Office Action Summary

10/595,342

HOUE, TERJE H.

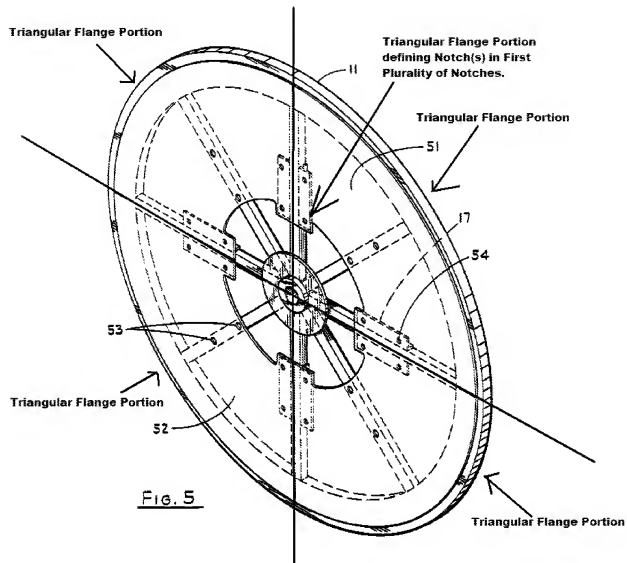
22. Regarding claim 35, Harvey further shows wherein each flange sector 51 is capable of comprising a series of triangular flange portions (see column 5 lines 7-12. figure 5 and figure below), the triangular flange portions defining notches in the first plurality of notches (see figure 5 and figure below).
